March 24, 2020

Please accept the comments of Hanford Challenge in response to the Class 2 Notice for a proposed permit modification to the Perma-Fix Northwest, Richland, Inc. Dangerous Waste Permit and TCSA Approval No. WAR 0000 10355. This is for the comment period from January 24, 2020 to March 24, 2020.

This modification was described as clarifications and updates to operational requirements of the In-Container Mixer Unit at the Perma-Fix Northwest mixed waste facility. Hanford Challenge has concerns and questions about Perma-Fix Northwest operations generally, as well as specific issues with the Permit Modification in question.

**Figure 1**  
**Plutonium-239 Processed at Perma-Fix Northwest**  
**2013-2018**  
**(grams)**

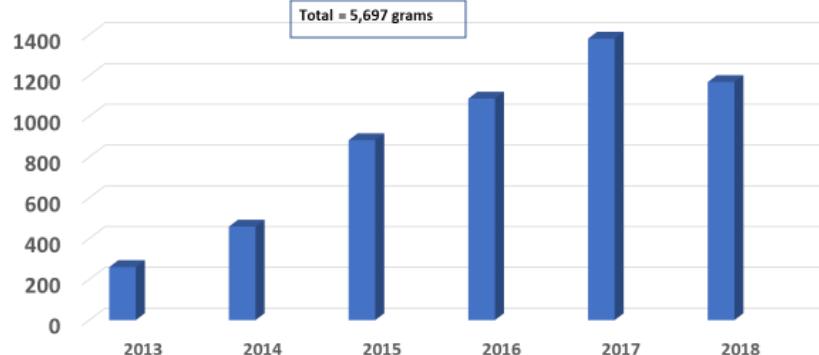
In 2005 the Washington State Department of Health (DOH) placed an annual possession limit for plutonium-239 at 25 Ci (697 grams)<sup>30</sup> to be processed at the Perma-Fix NW facility. According to Perma-Fix NW annual environmental reports this limit was exceeded in 2015 (883g)<sup>31</sup>, 2016(1,087g)<sup>32</sup>, 2017 (1,381g)<sup>33</sup> and 2018 (1,1186g).<sup>34</sup>

Did Perma-Fix NW seek approval for these increased amounts of Pu-239 and if so, what was the justification the approval(s)?

See Figure 1.
